SUNDRY NOTICES AND REPORTS ON WELLS

8. Well Name and No.
Schalk 57 #1E

PLUG AND ABANDONMENT PROCEDURE

CONDITIONS OF APPROVAL

Proposed P&A Basin Dakota

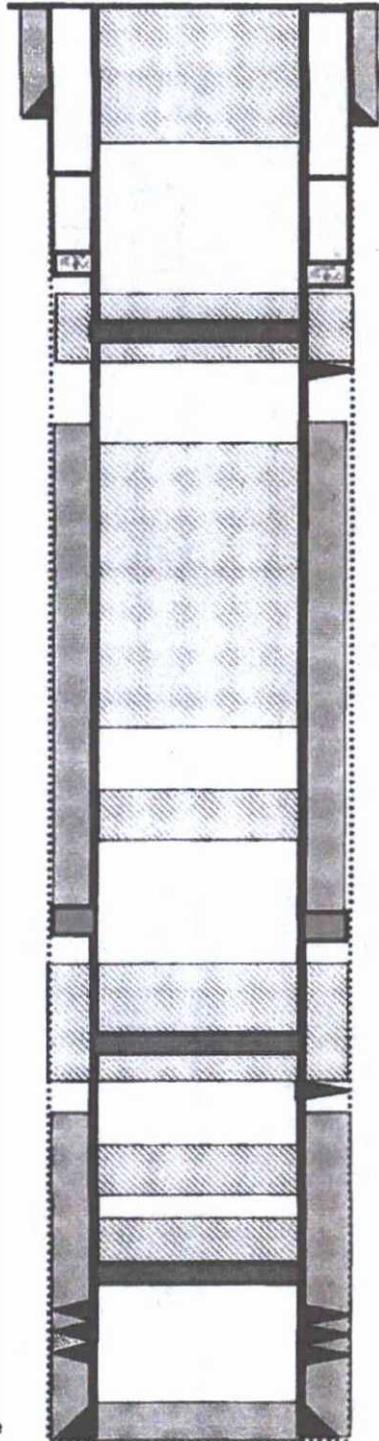
1. Plugging operations authorized are subject to the attached "General Requirements for Permanent Abandonment of Wells on Federal and Indian Leases."
2. Farmington Office is to be notified at least 24 hours before the plugging operations commence (505) 564-7750.
3. The following modifications to your plugging program are to be made:
 - a) Set Plug #2 (7090-6990) ft. to cover the top of the Gallup top. BLM picks top of Gallup at 7040 ft.
 - b) Set Plug #3 (6490-6390) ft. inside/outside to cover the Mancos top. BLM picks top of Mancos at 6440 ft.
 - c) Bring the top of Plug #5 to 2761 ft. to cover the top of the Pictured Cliffs, Fruitland, Kirtland and Ojo Alamo tops.
 - d) Bring the top of Plug #6 to 1464 ft. to cover the Nacimiento top. BLM picks top of Nacimiento at 1514 ft.

Top of the Chacra at 4486 ft. will be used for top of Mesaverde for plugging proposes (plug #4).

Operator will run a CBL to verify cement top. Outside plugs will be adjusted accordingly. Submit the electronic copy of the log for verification to the following addresses: jwsavage@blm.gov tsalyers@blm.gov Brandon.Powell@state.nm.us
